NOTICE OF ADDENDUM
ADDENDUM NO. 3
City of Madison, Engineering Department

CONTRACT NO. 8981
METRO TRANSIT PHASE 3A – MAINTENANCE AND DRIVER FACILITY IMPROVEMENTS

This addendum is issued to modify, explain or correct the original Drawings, Specifications, or Contract Documents marked as *Metro Transit Phase 3A–Maintenance and Driver Facility Improvements, City of Madison, Contract #8981, as issued on April 8th, 2021* and is hereby made a part of the contract documents.

12 TRAPEZE FRAMING
1" = 1'-0"

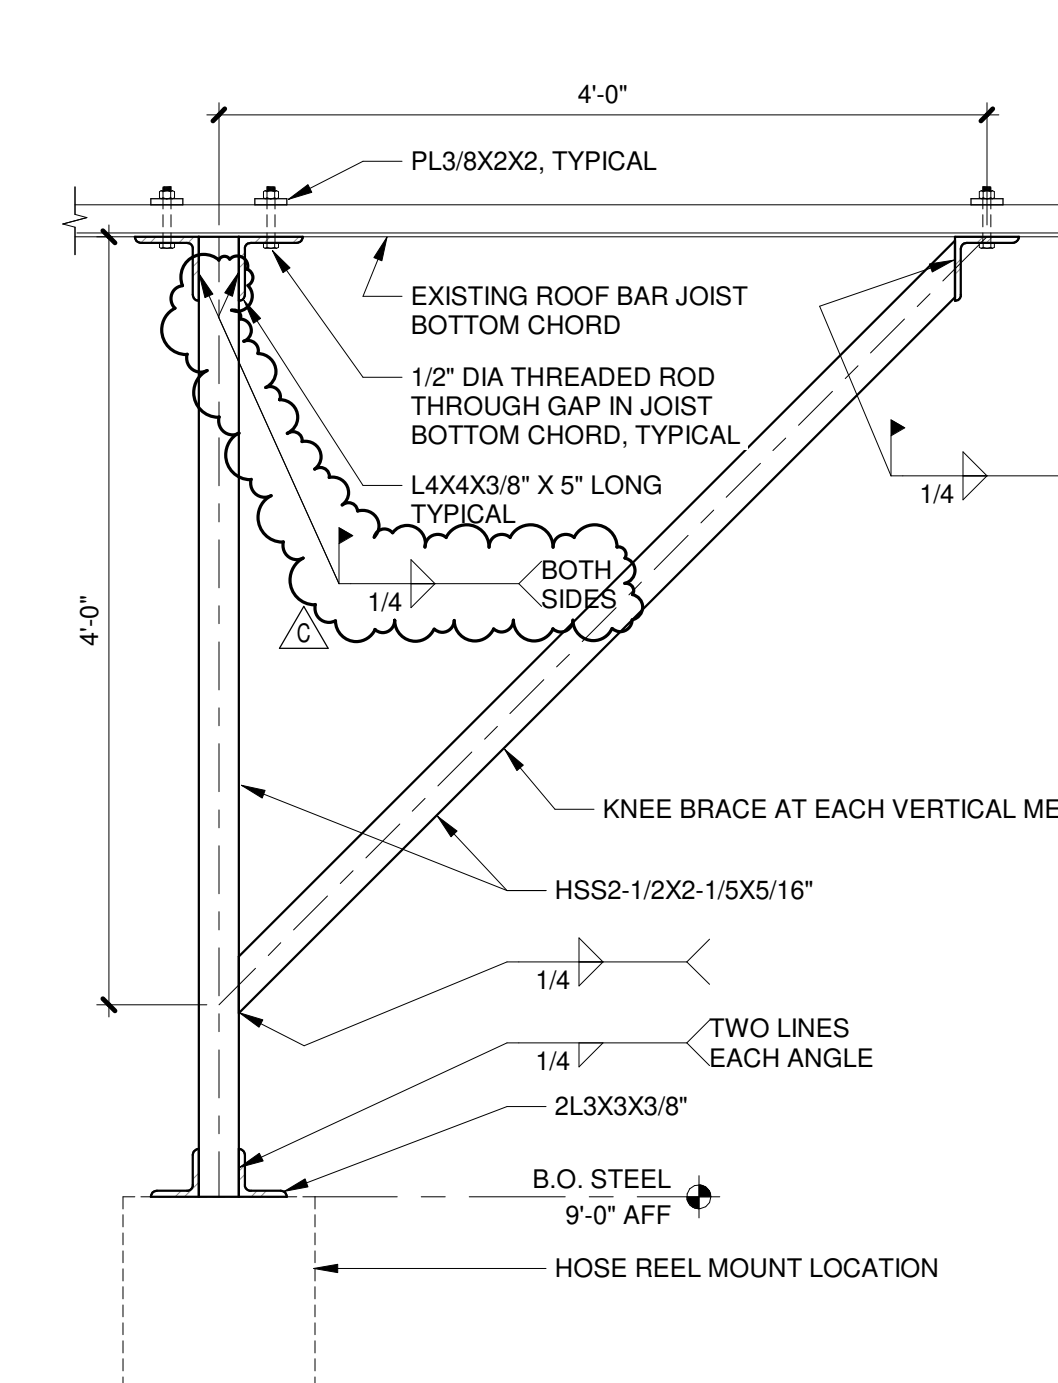
- Added keyed note 3.507
- xi. Drawing S-501(attached); Deleted rebar terminations on detail 5
- xii. Drawing S-511 (attached); Added detail 14
- xiii. Drawing S-541 (attached); Add weld to detail 12

SHEET NO.:
A-102F

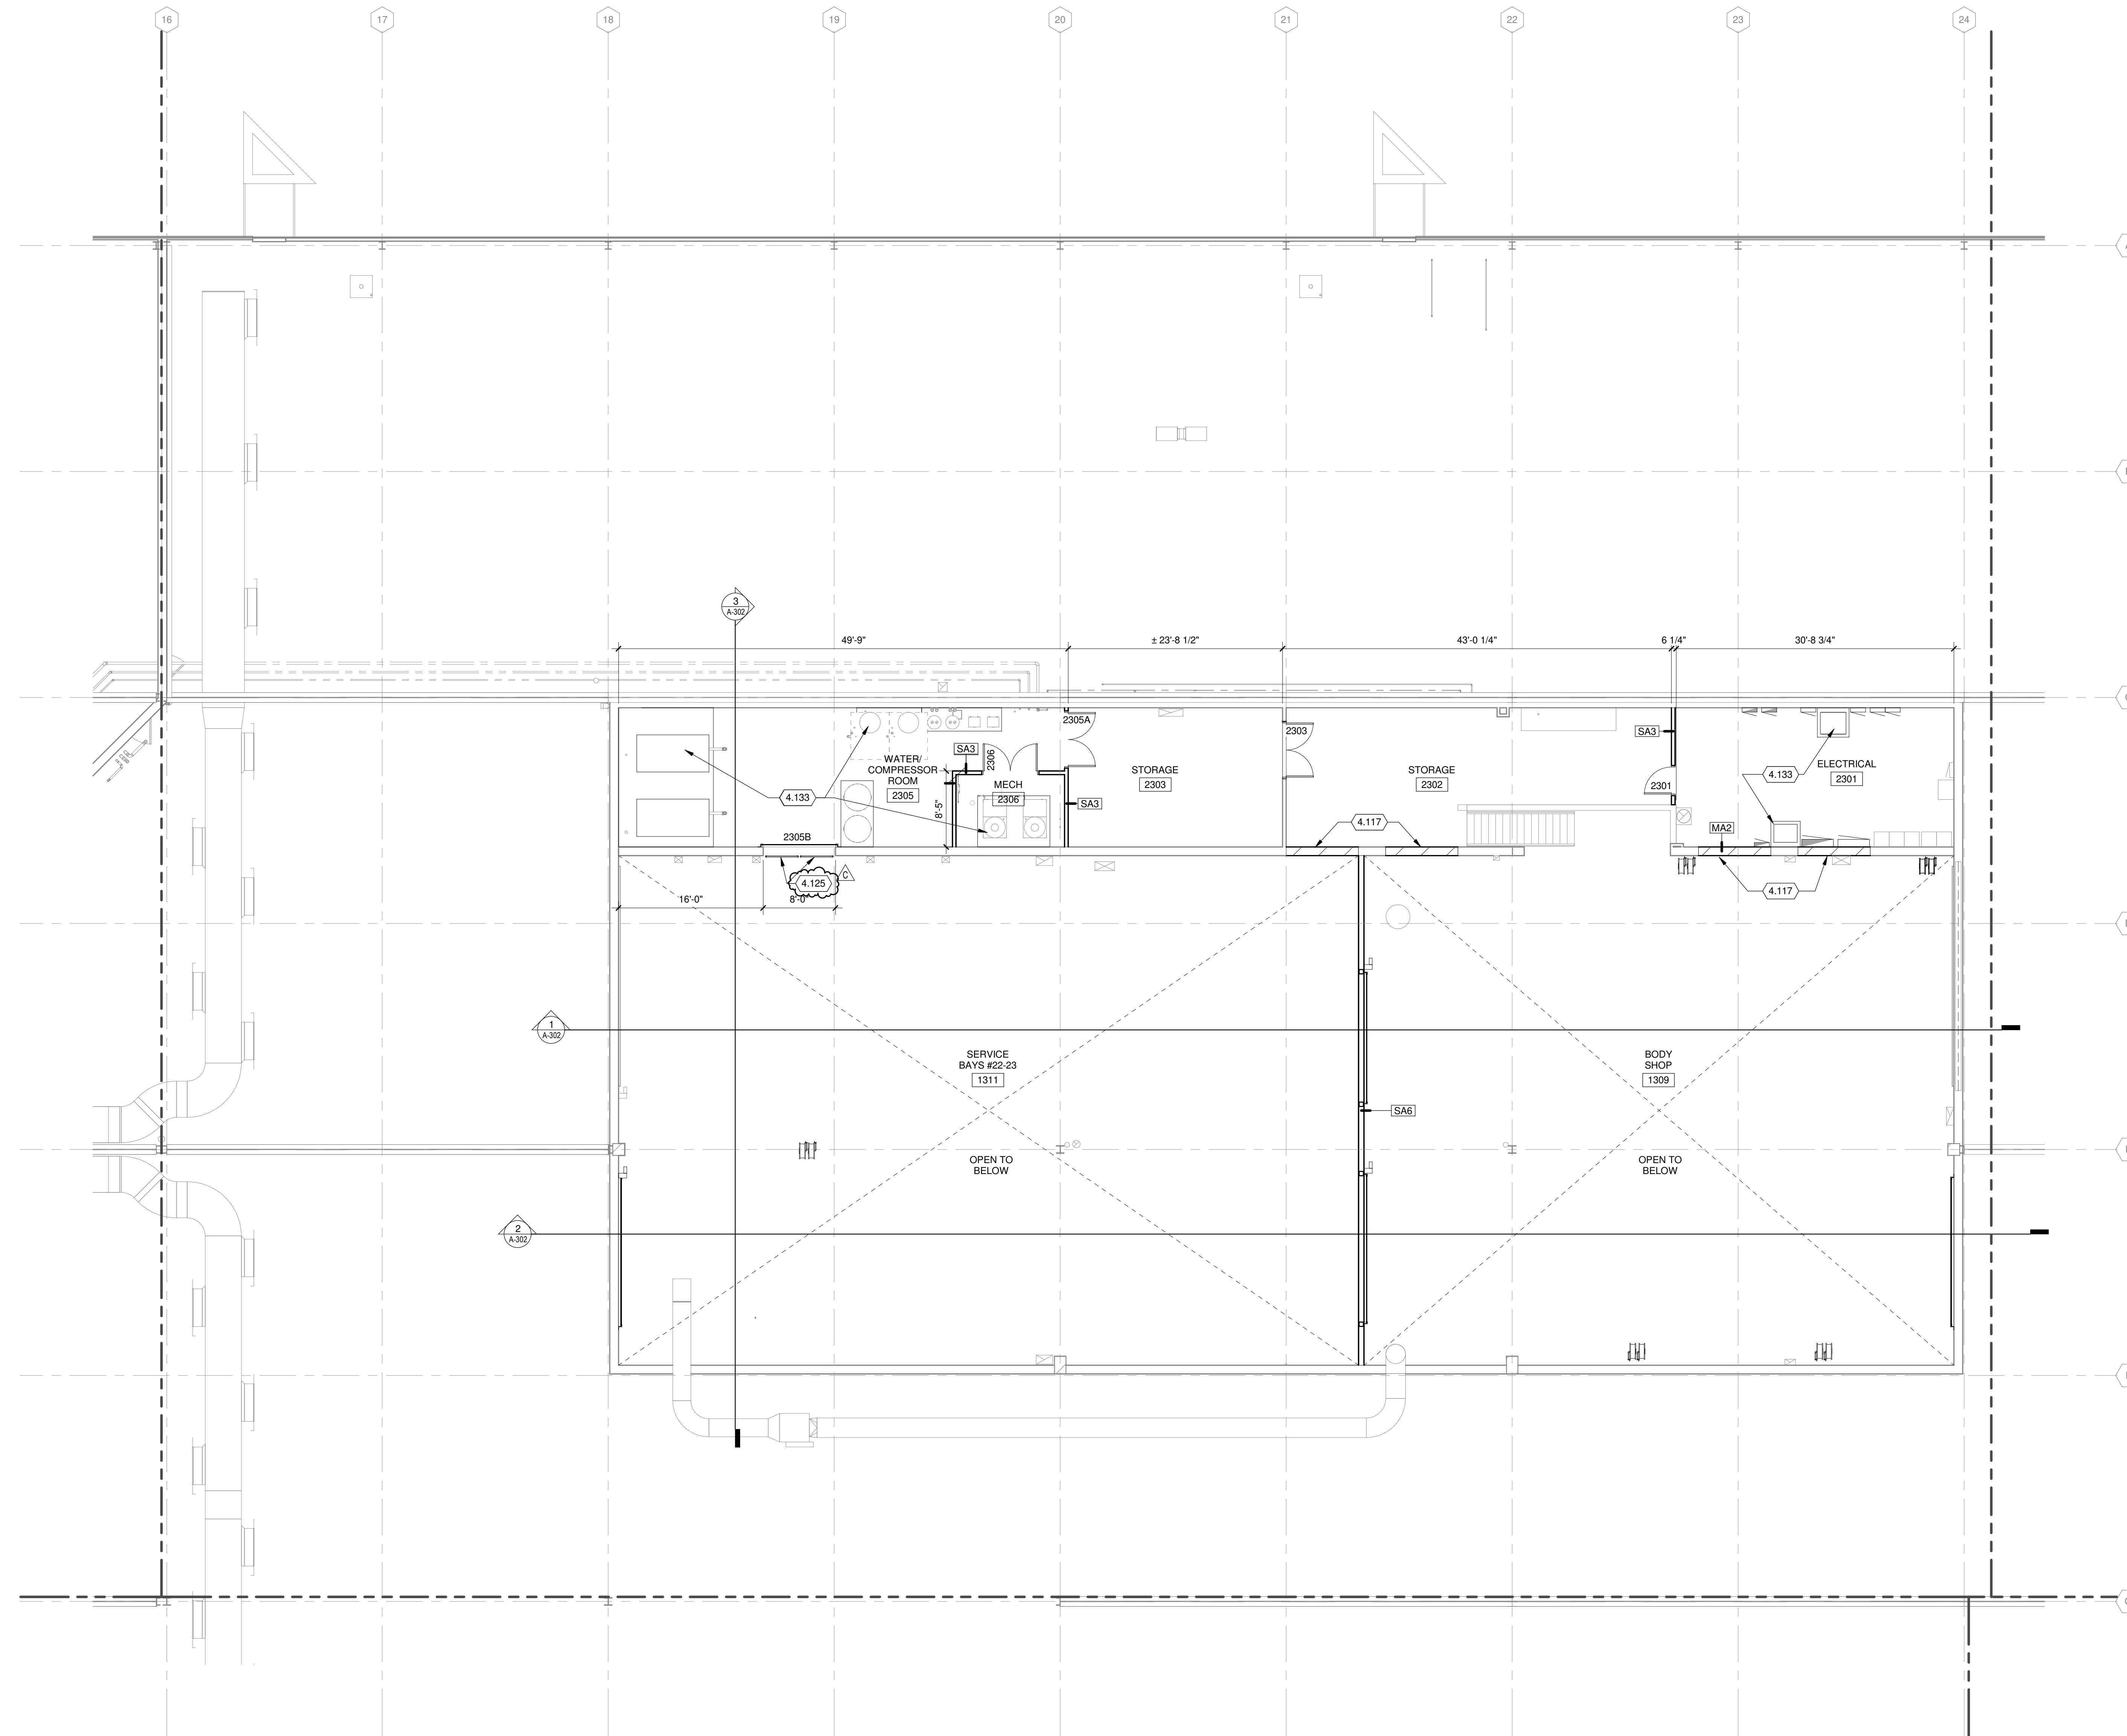
- Add keynote 4.138 to concrete end of landscape wall near door 1101B.
- Add keynote 4.138.
- ii. Drawing A-102F (attached),
 - Revise keynote pointing at railings by door 2305B to 4.125.
 - Add keynote 4.125.
- iii. Drawing A-201 (attached),
 - West building elevation 1, revise keynote near door 1101B to 4.138.
 - Add keynote 4.138.
- iv. Drawing A-301 (attached), building section 4, revise detail to coordinate structural modification.
- v. Drawing A-312 (attached),
 - Revise Wall Section 4 for coordination of structure for the folding panel partition.
 - Add Wall Section 5 for coordination of structure for the folding panel partition.
- vi. Drawing A-501 (attached), revise detail 15 to coordinate structural modification.

1 FIRST FLOOR FINISH PLAN - AREA A
1/8" = 1'-0"

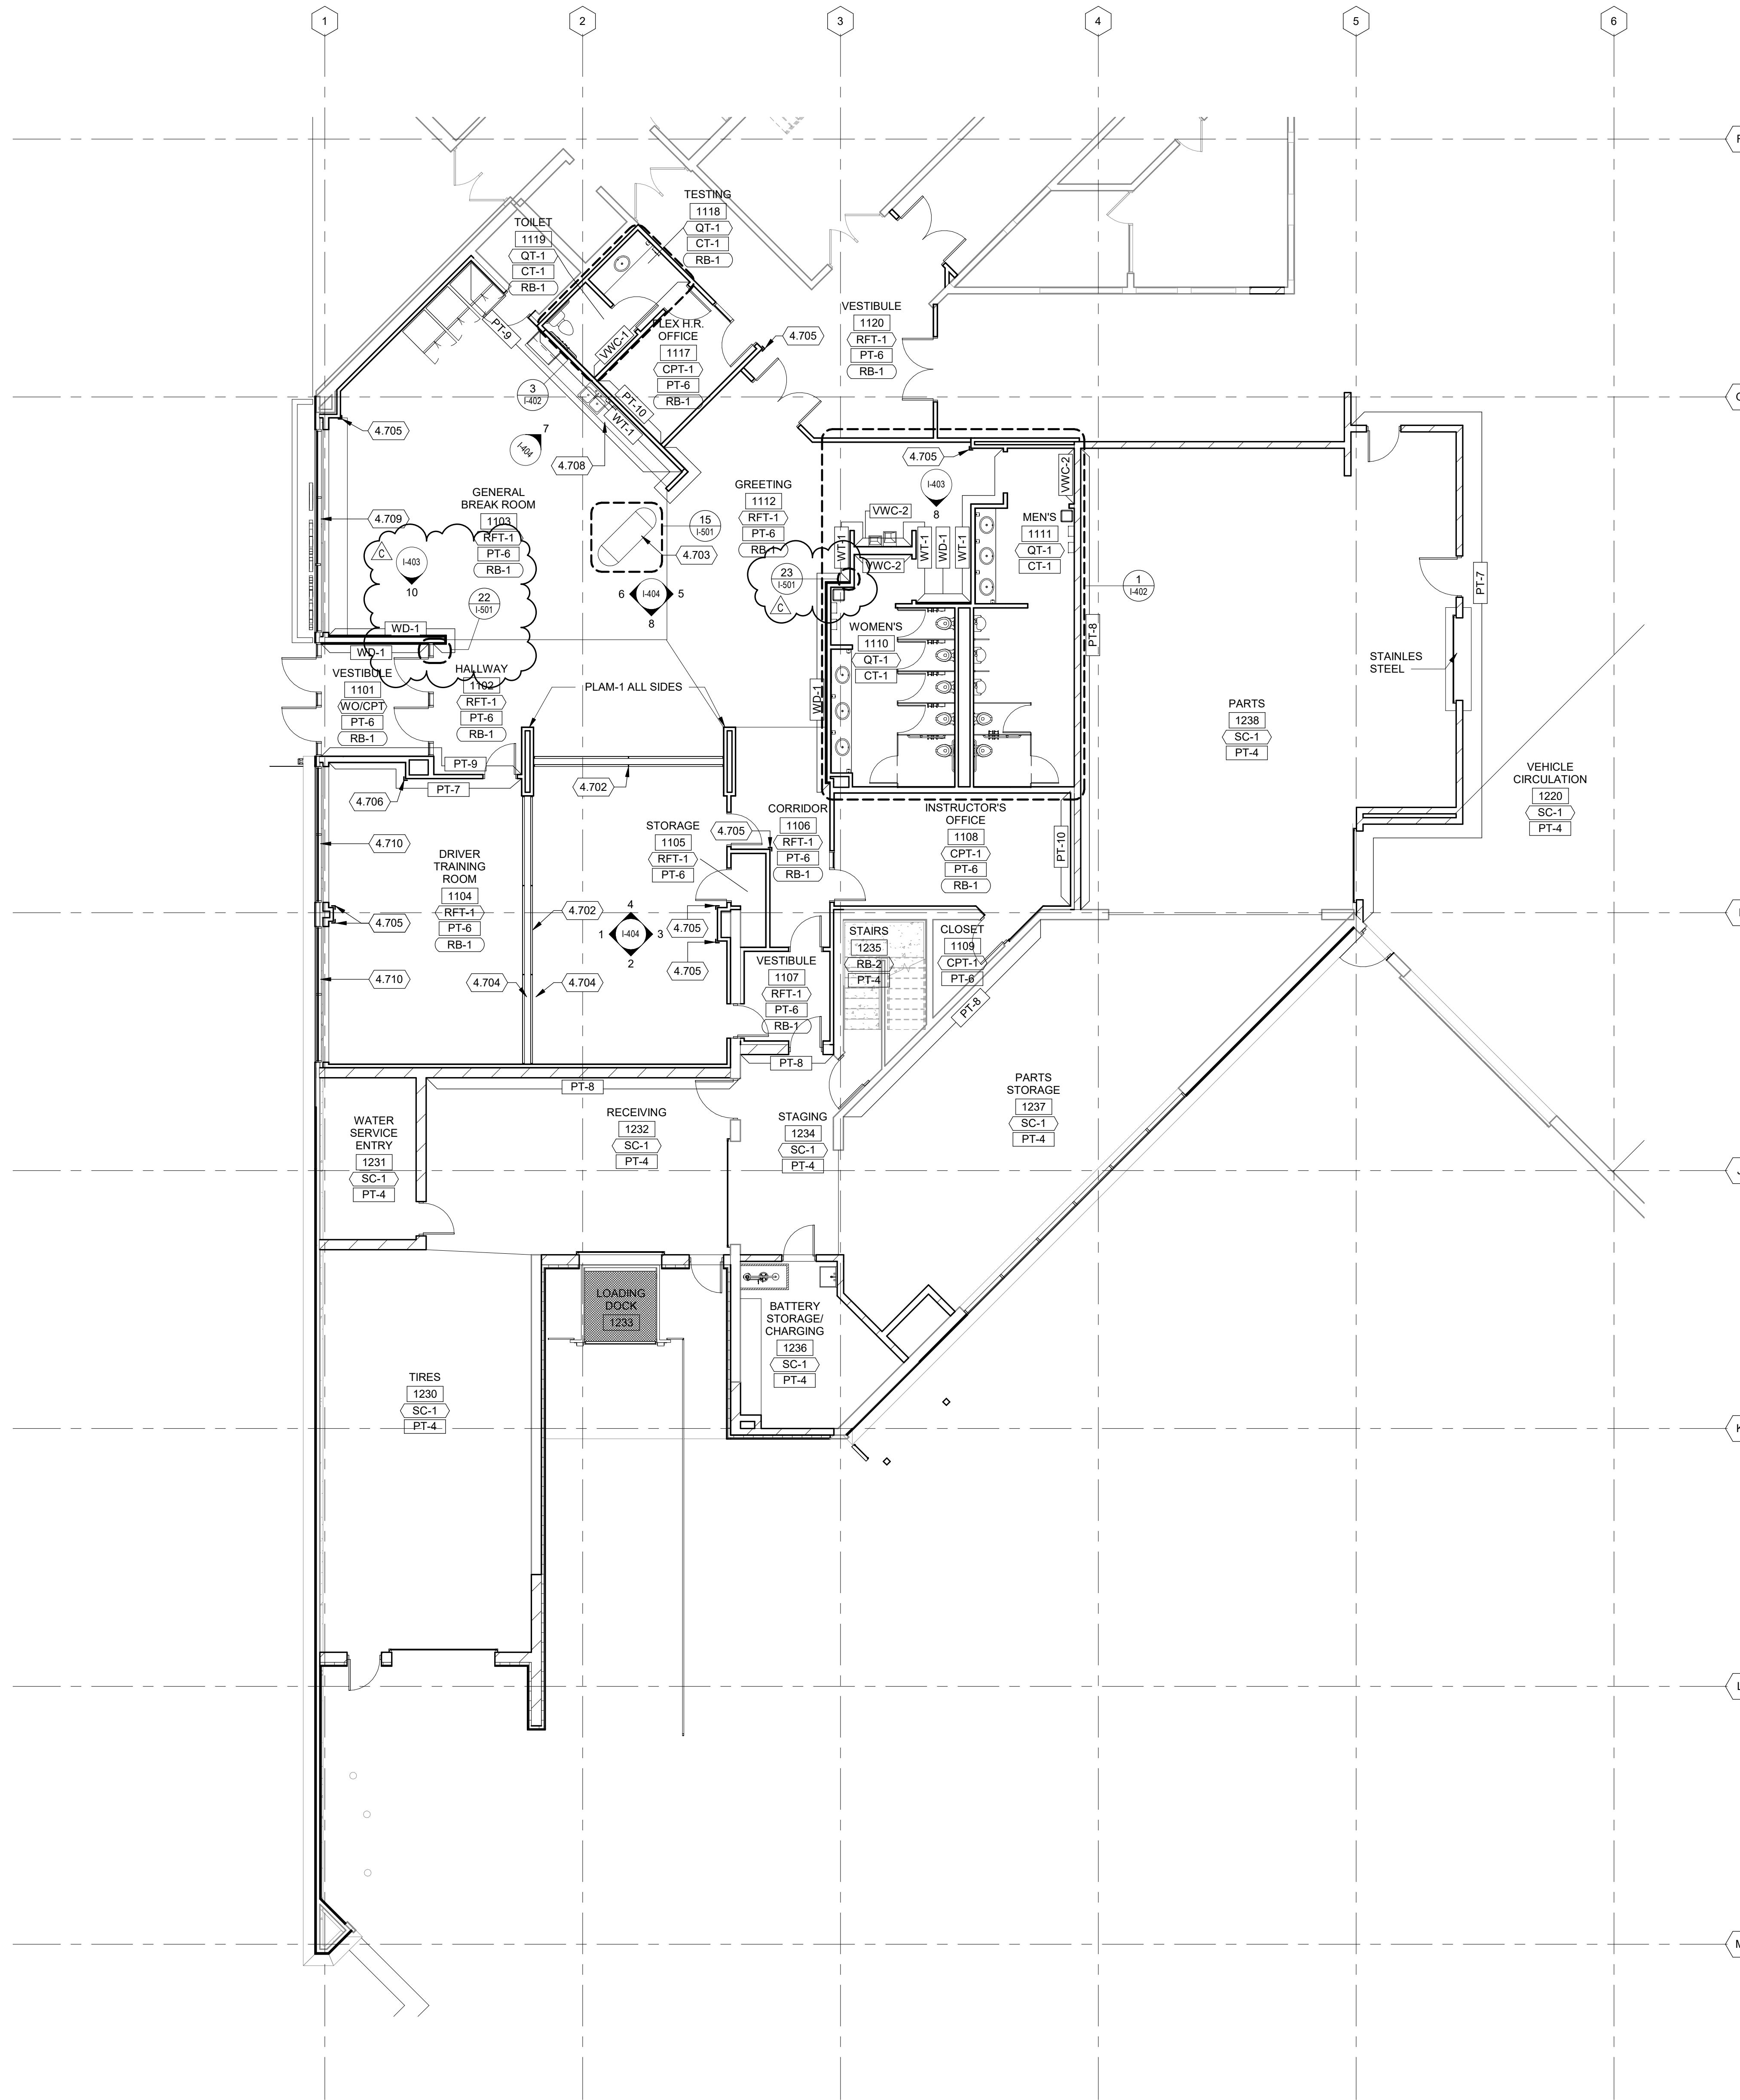
- i. Drawing I-101A (attached);
 - Add interior elevation symbol 10/I-403
 - Add enlarged plan detail symbol 22/I-501
 - Add enlarged plan detail symbol 23/I-501
